Mandalong Southern Extension Project

MOD 10

Submissions Report

December 2021

\\EMMSVR1\centennial_coal\12.10436 - Mandalong Mine - Mod 10\GIS\02_Maps\G006_AprovedMinePlanMod9_20210819_03.mxd 19/08/2021

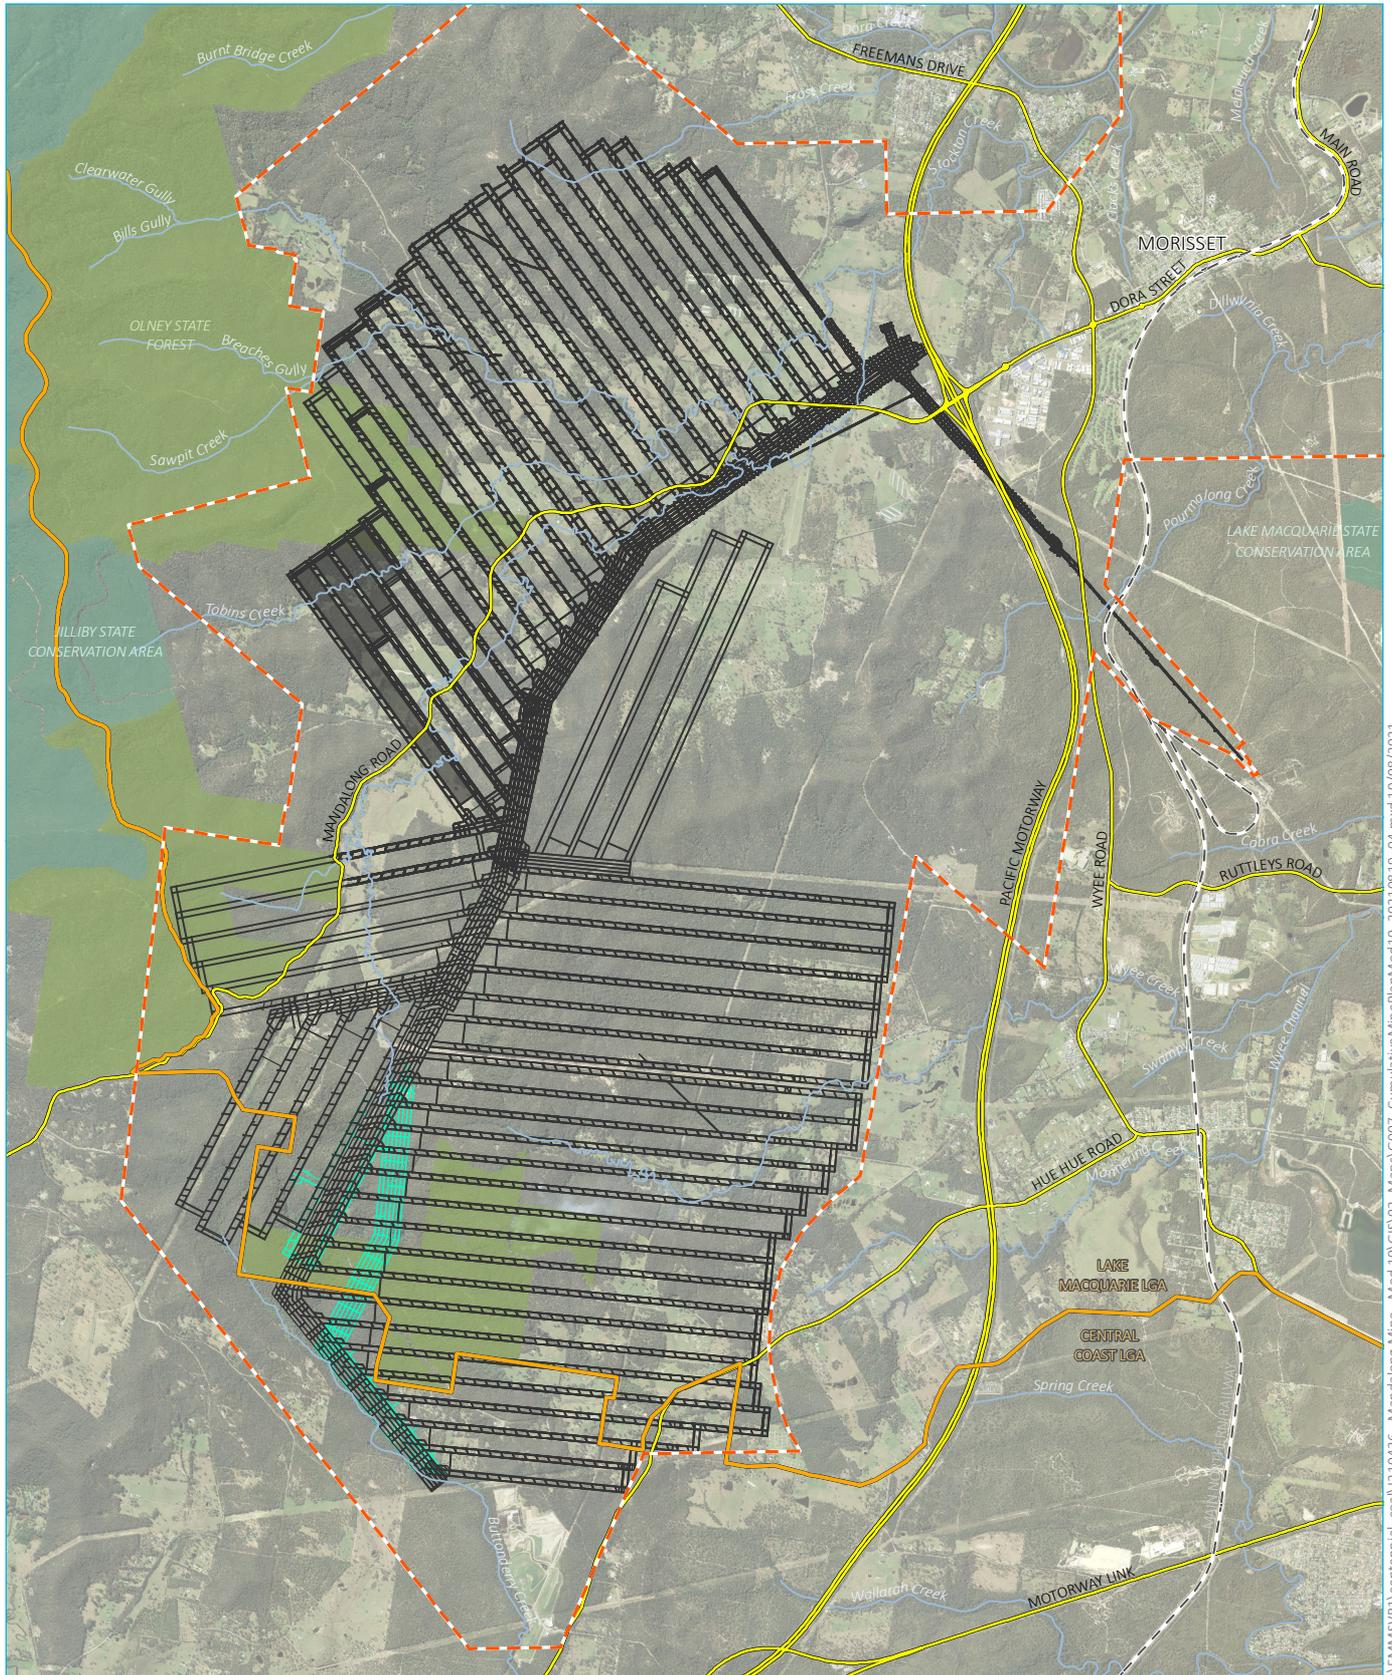
Ten (10) modifications to the Mandalong Southern Extension Project have been pursued since development consent (SSD-5144) was granted in October 2015. Five modifications are associated with changes to the mine design (MOD 2, MOD 4, MOD 5, MOD 9 and MOD 10). The figures provided as **Attachment 1** show the evolution of mine design changes through the modification process. The changes to the mine design have been necessary to adapt to updated geological information not available at the time the EIS was submitted. Centennial Mandalong consider the changes to the mine design, as shown by the figures provided in **Attachment 1**, to be substantially the same development as originally approved.
